U.S. NUCLEAR REGULATORY COMMISSION

Reports No. 50-295/OLS-86-01

Licensee: Commonwealth Edison Company
Zion Generating Station
Zion, Illinois

Examination Summary

FIG 1.1

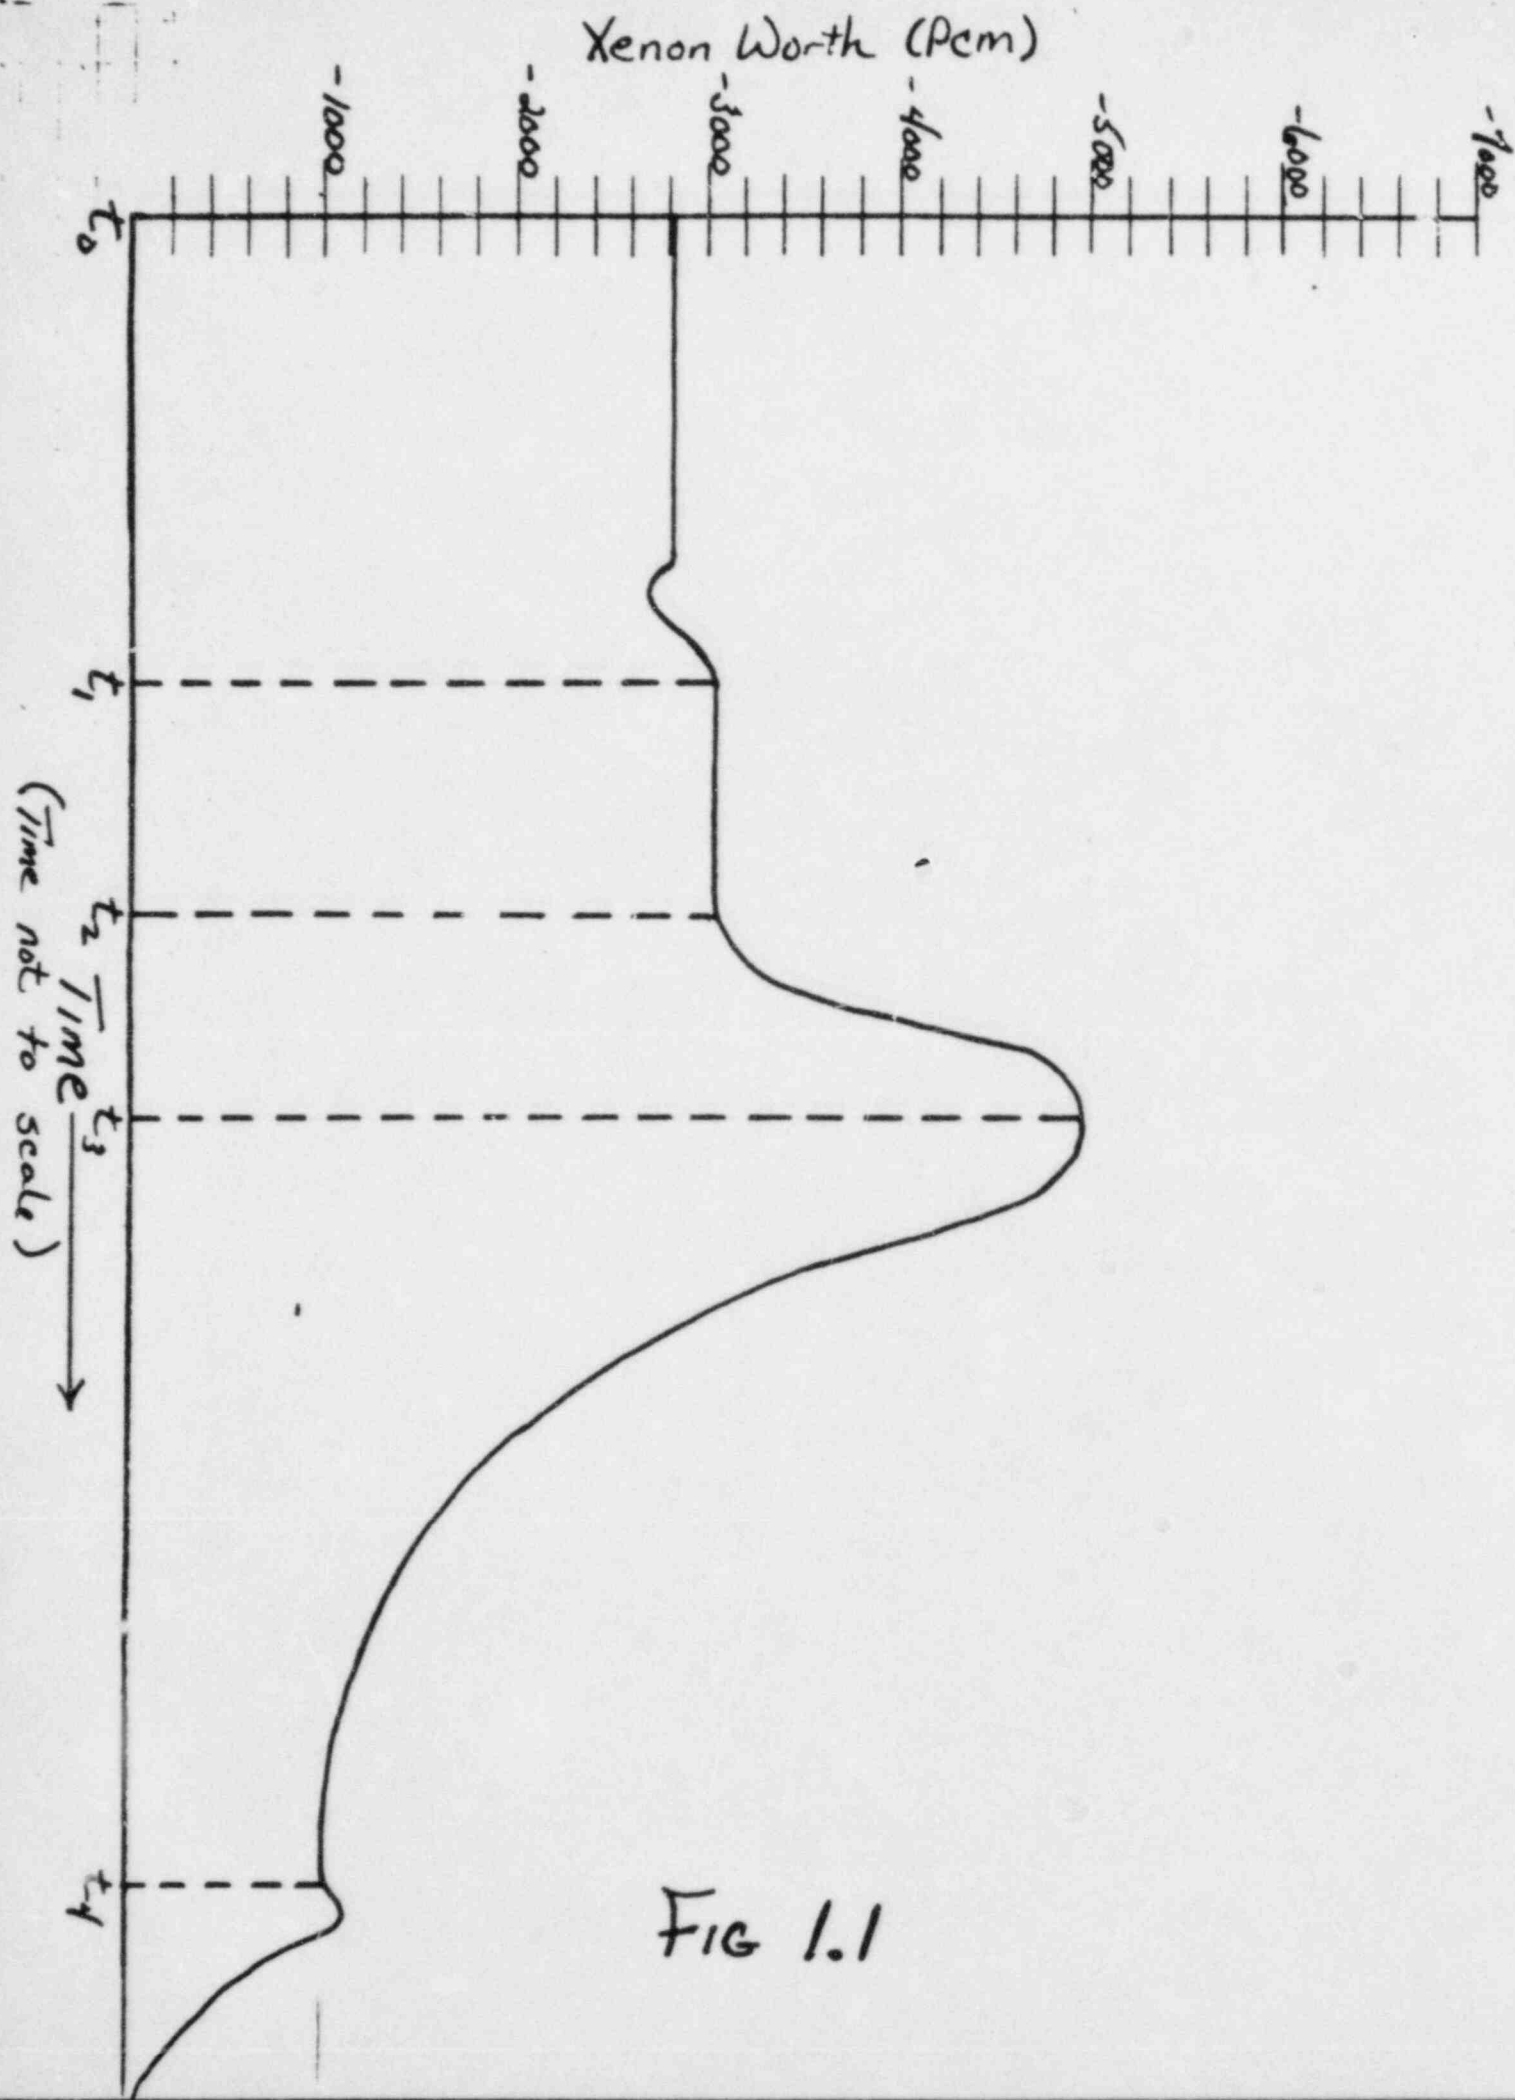
Question 1.06 Facility Comment:

The graph provided makes it difficult to arrive at the answers as stated in the key. It is requested that more tolerance be allowed when grading this question.

NRC Response: Reasonable answers which give approximate power levels and time frames were awarded full credit.

Mollier diagram (h-s) for steam.

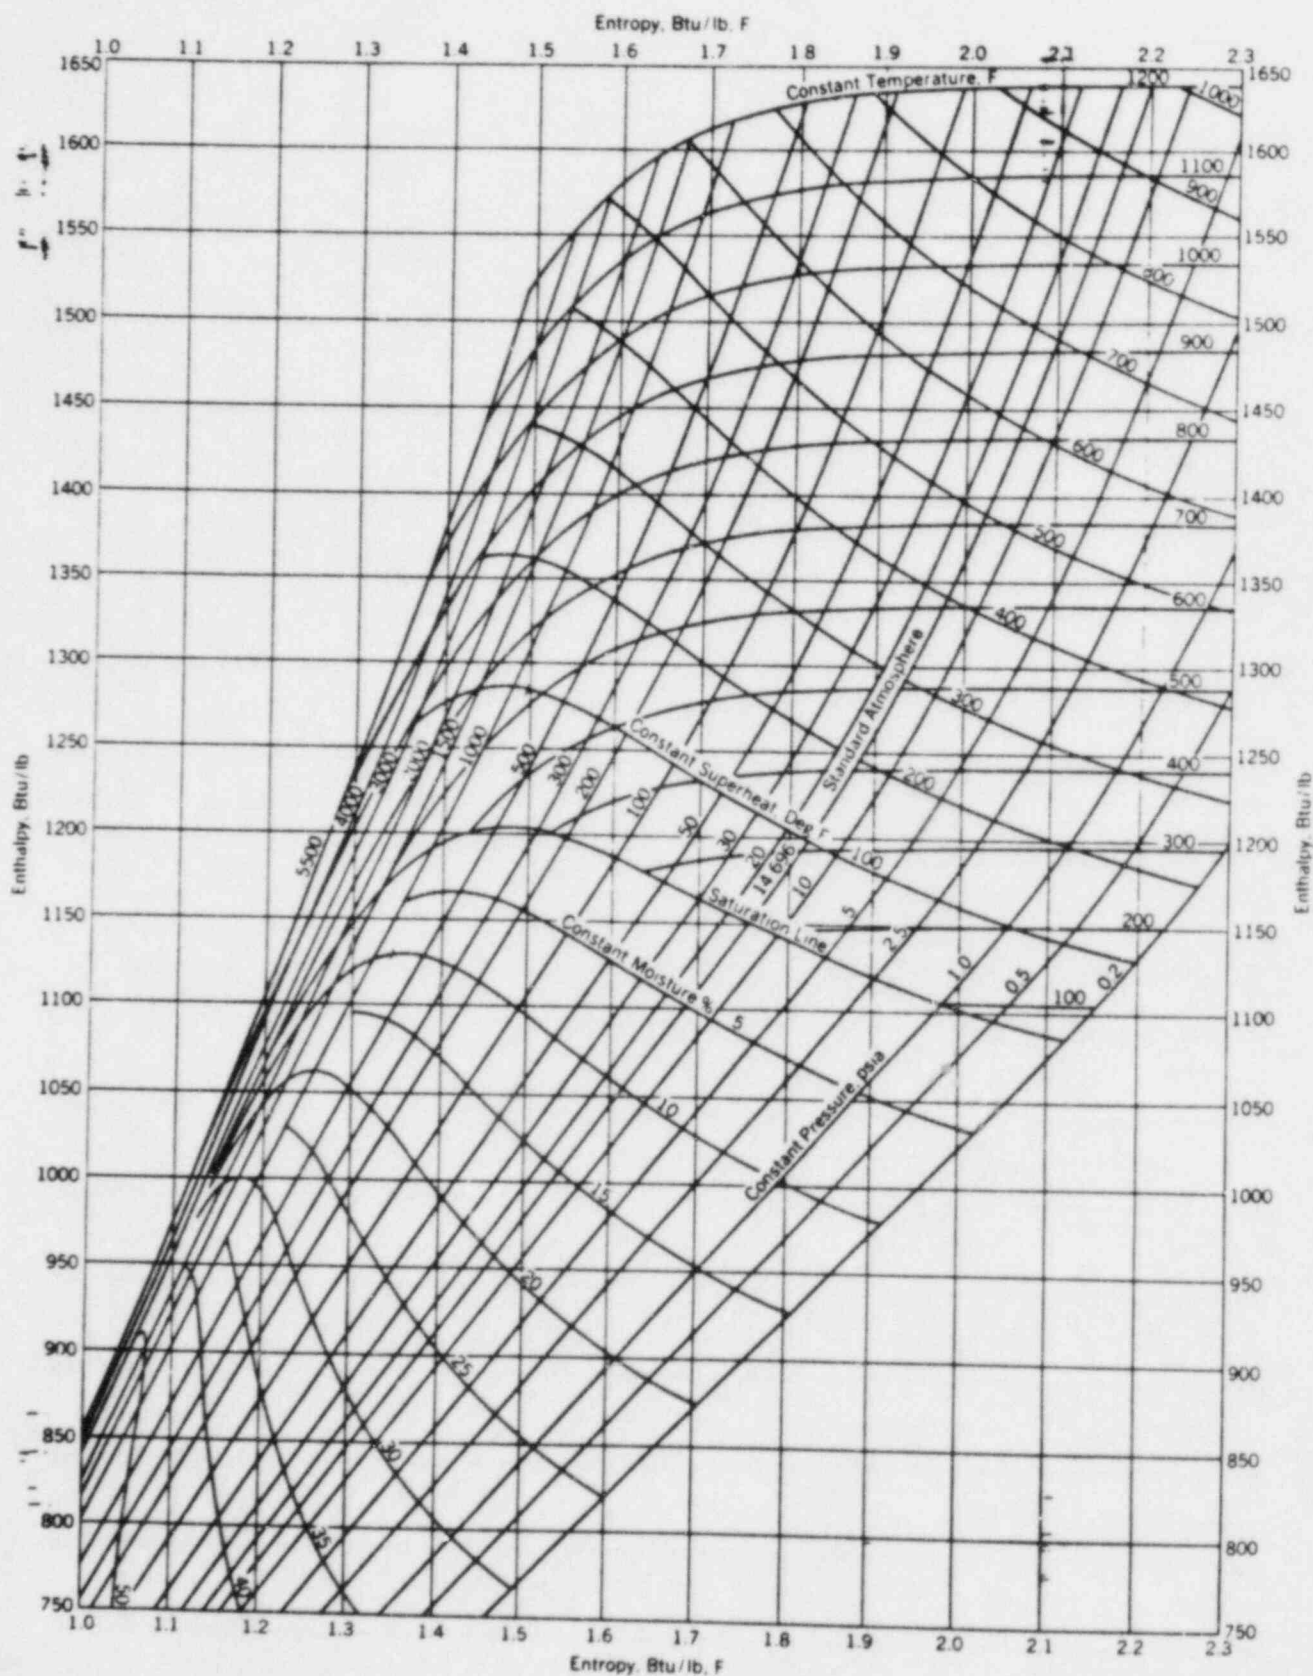
Question 1.11 Facility Comment:

It is requested that a larger margin of error be allowed due to the difficulty in reading the Mollier Diagram.

NRC Response: Agree. Answers within 10 BTU per pound mass of the correct answer were awarded full credit.
